STBG-0010-01(180)/ 109171301000

This Addendum forms a part of the Contract Documents and modifies the January 30, 2026 Issued for Bid documents with amendments and additions noted below.

I-10 JACKSON COUNTY WELCOME CENTER

SHEET ID
UTIL-8
SHEET NO.
68

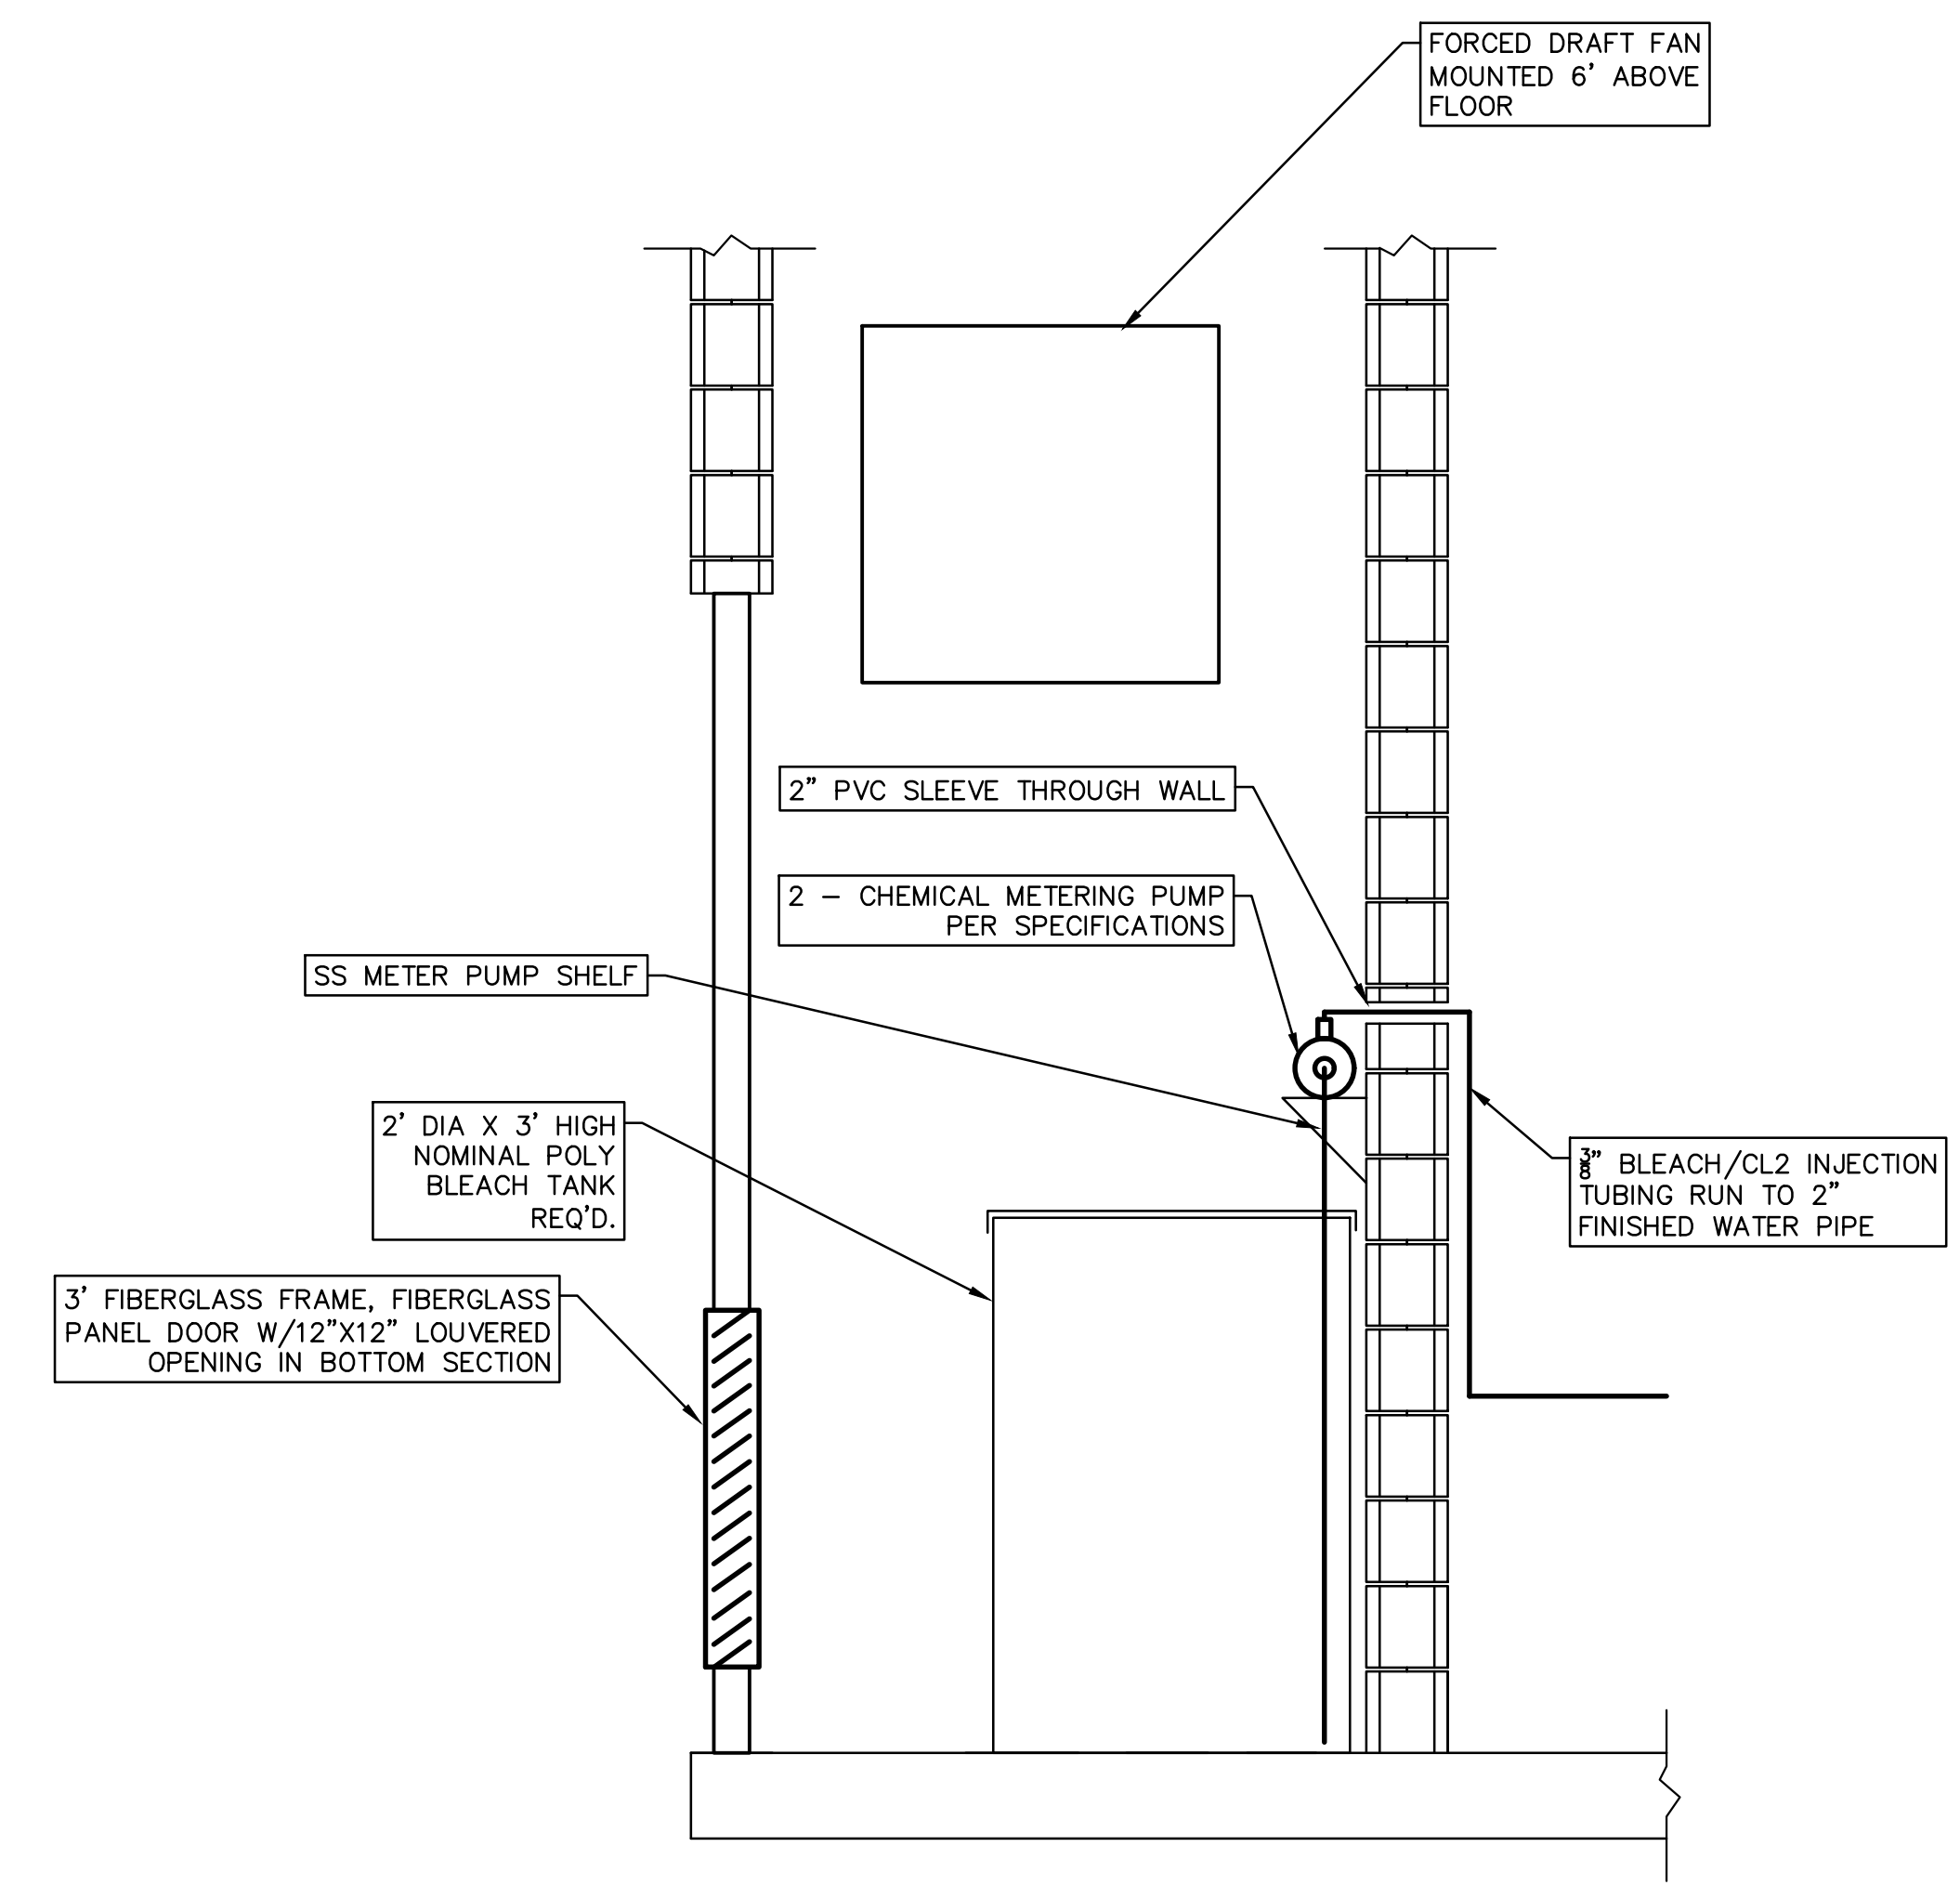
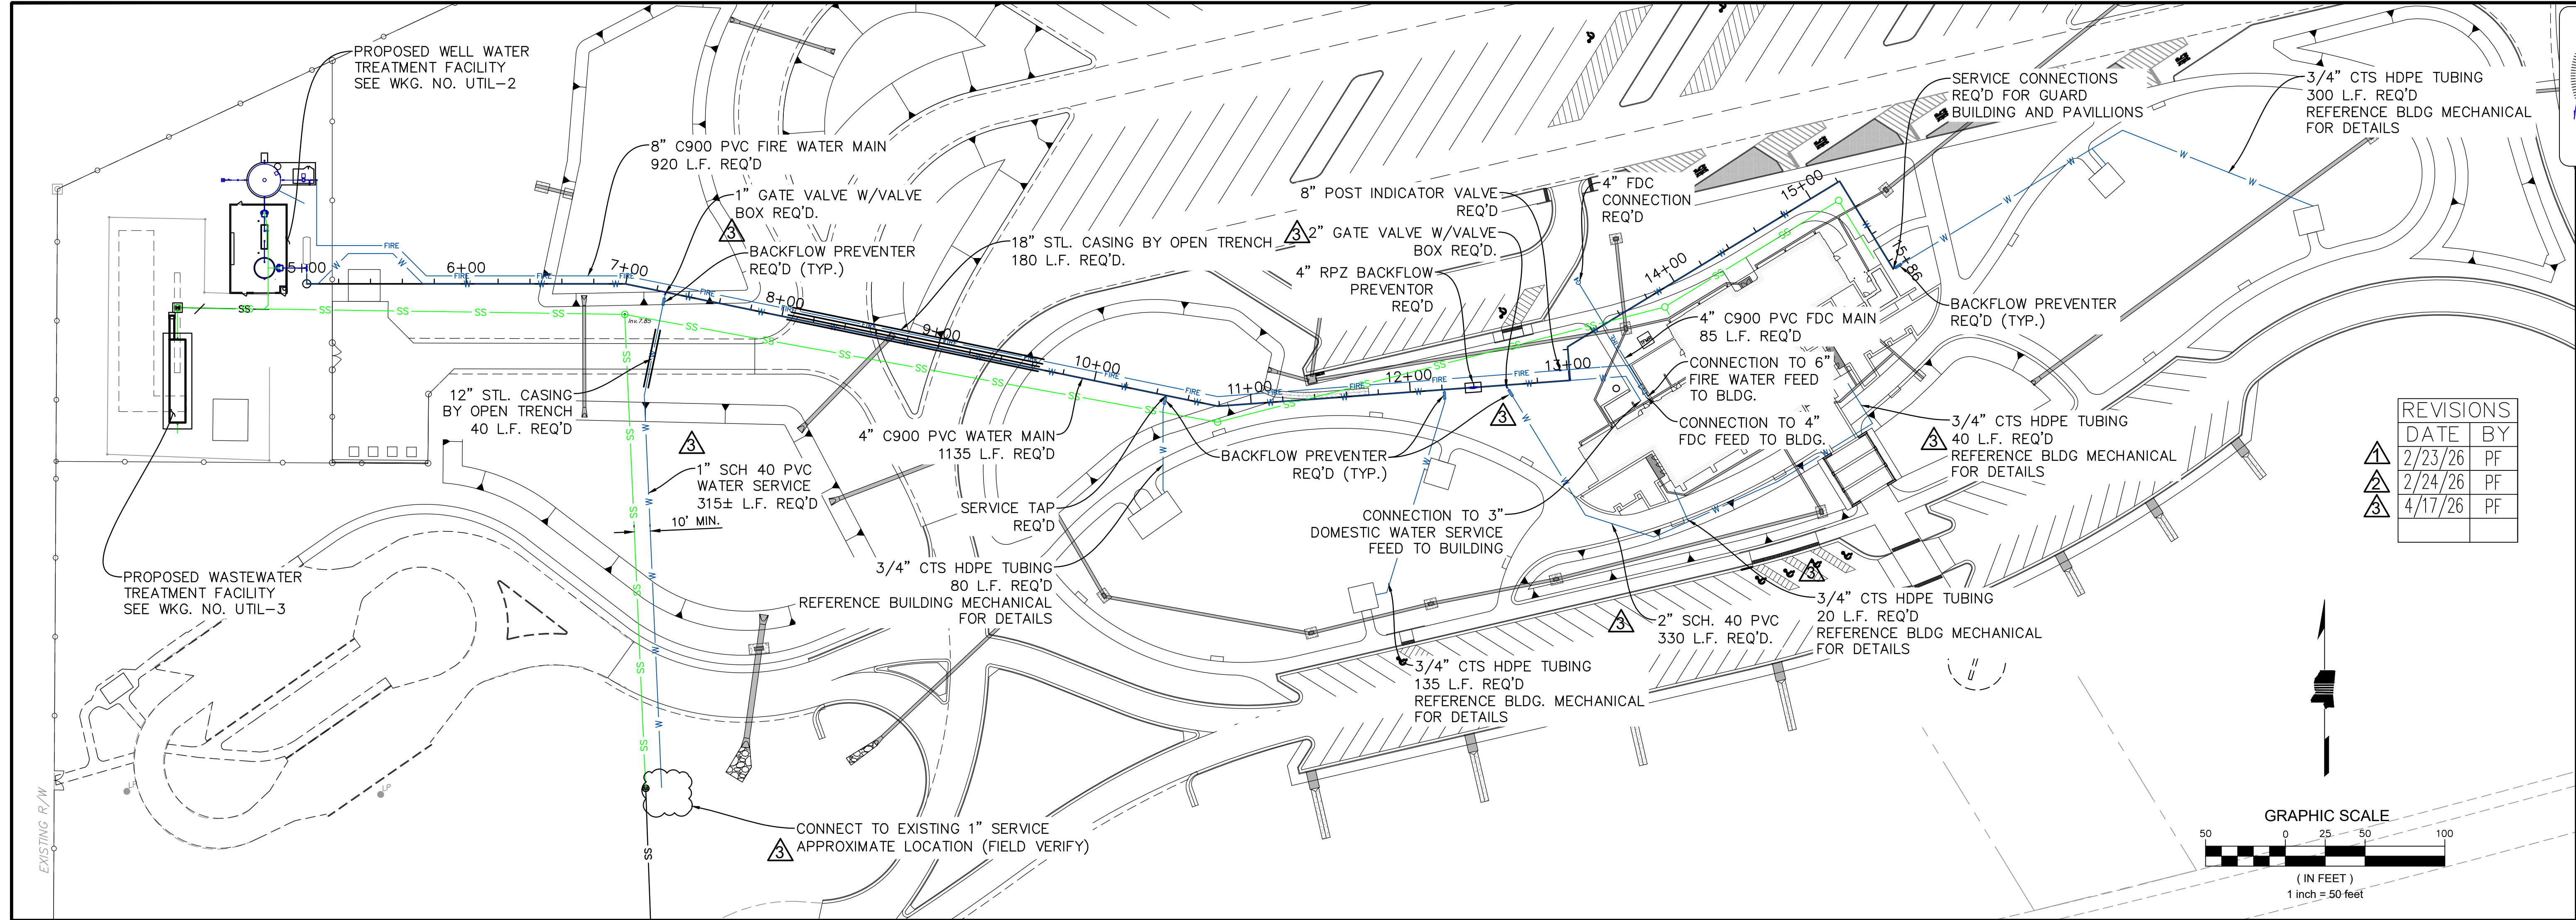
Plan sheets Util - 6, 8 and 10 have been changed to add the new water line to feed the hydrants on the front of the building and to indicate the change from gaseous chlorine to liquid bleach for the water disinfection.

WATER MAIN & SERVICES
PLAN & PROFILE
STA. 5+00 TO STA. 16+00

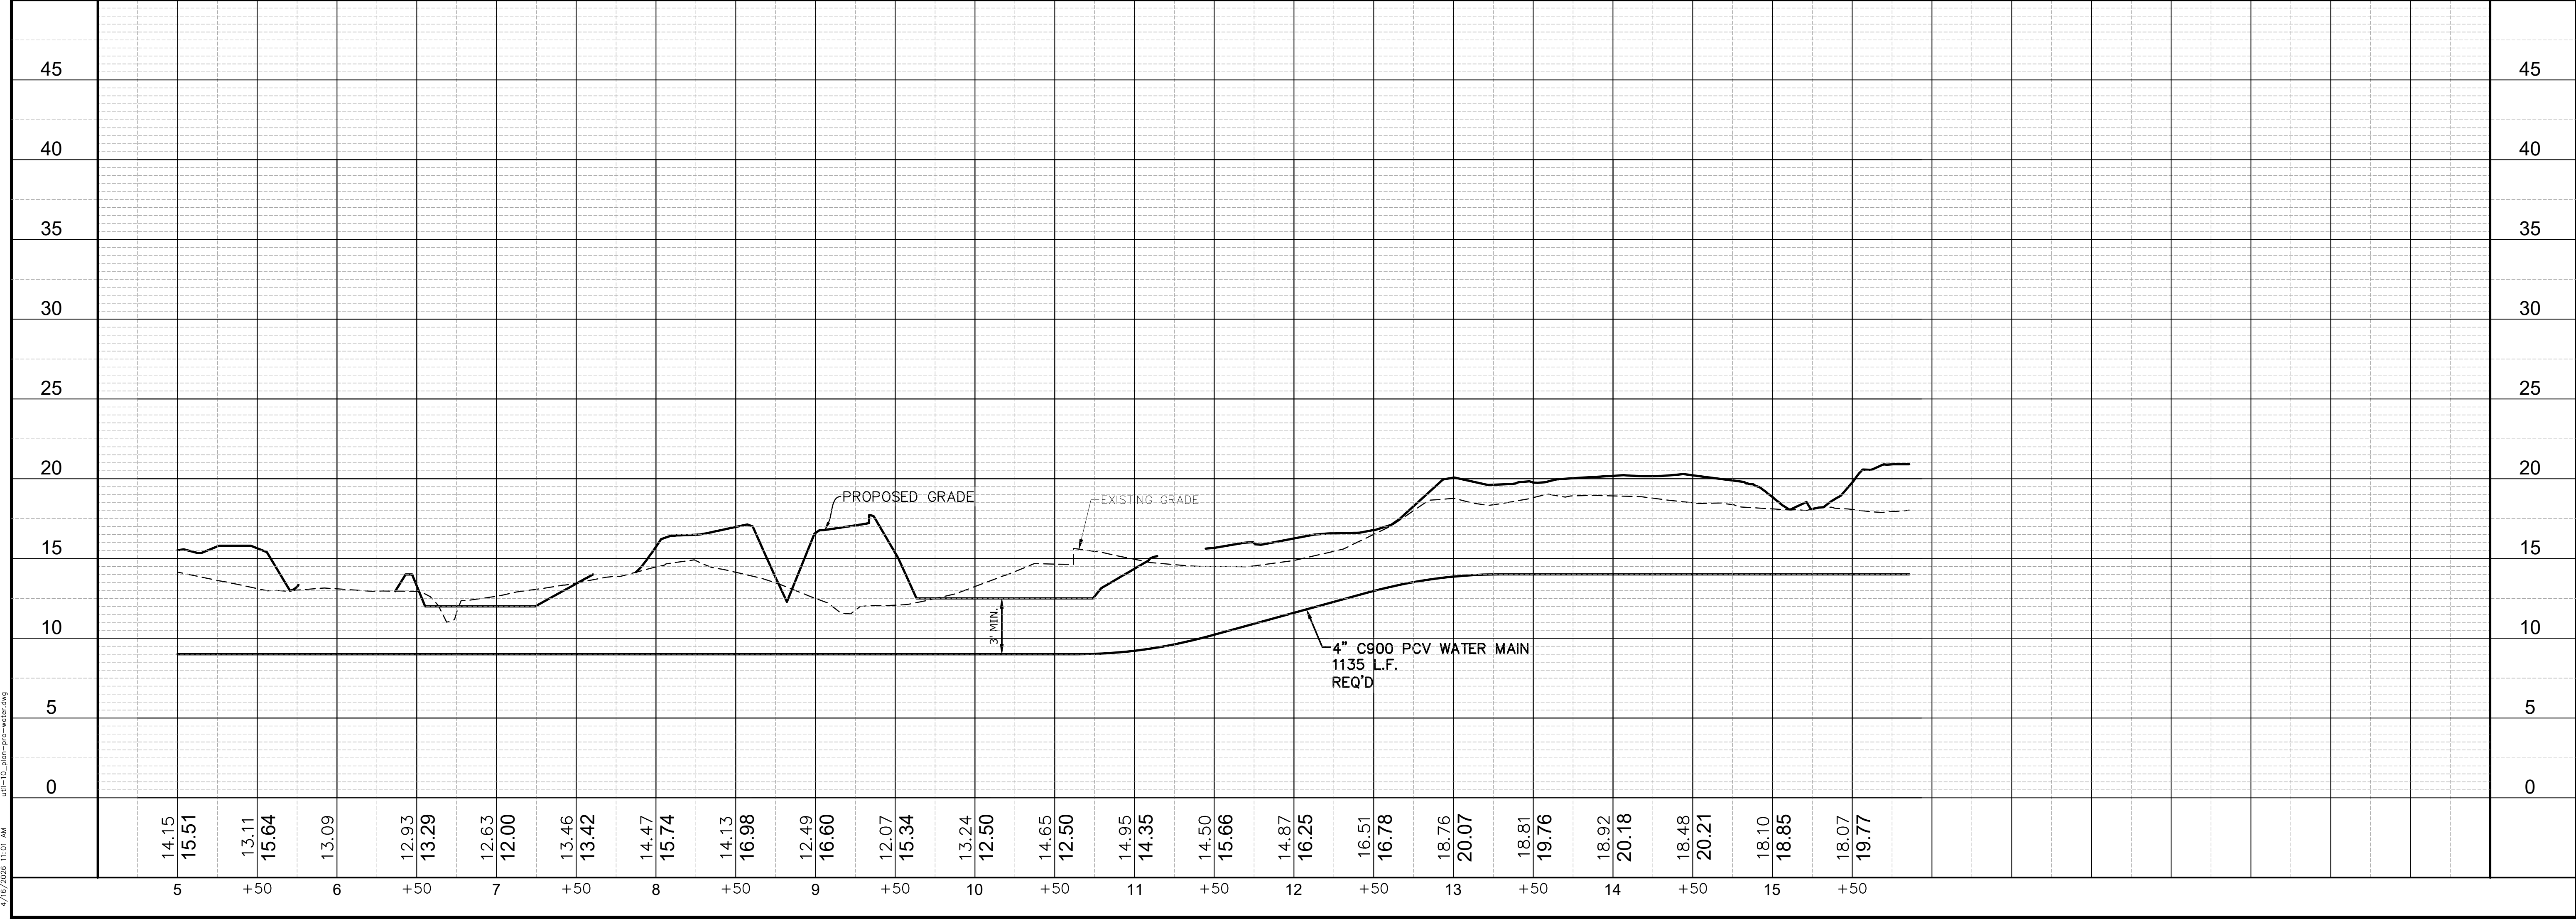
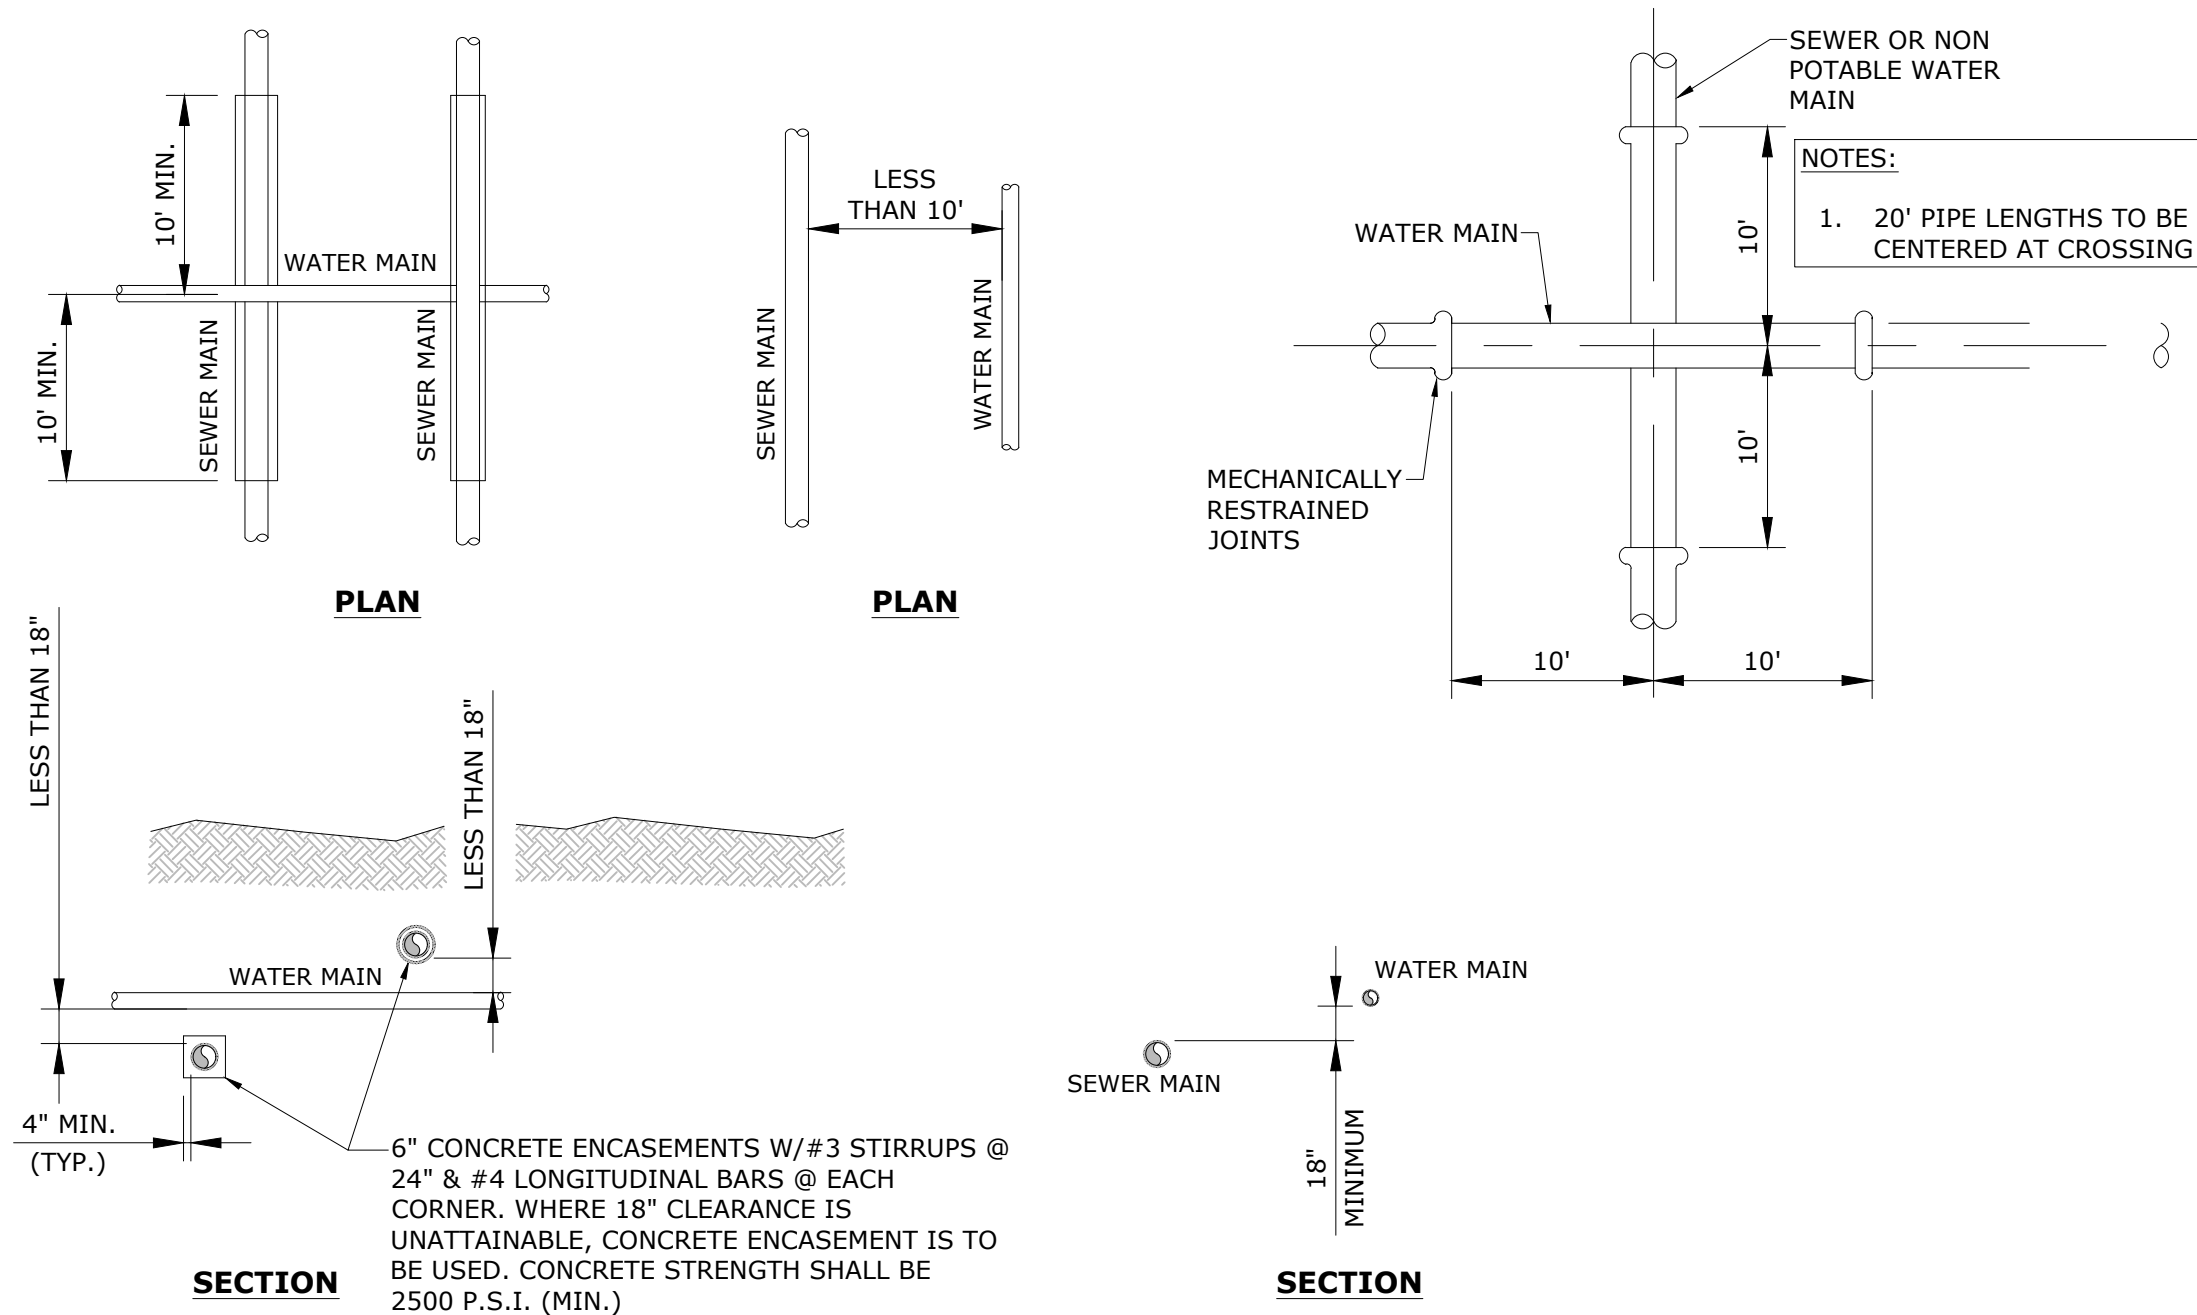
Plan sheets Util - 6, 8 and 10 have been changed to add the new water line to feed the hydrants on the front of the building and to indicate the change from gaseous chlorine to liquid bleach for the water disinfection.
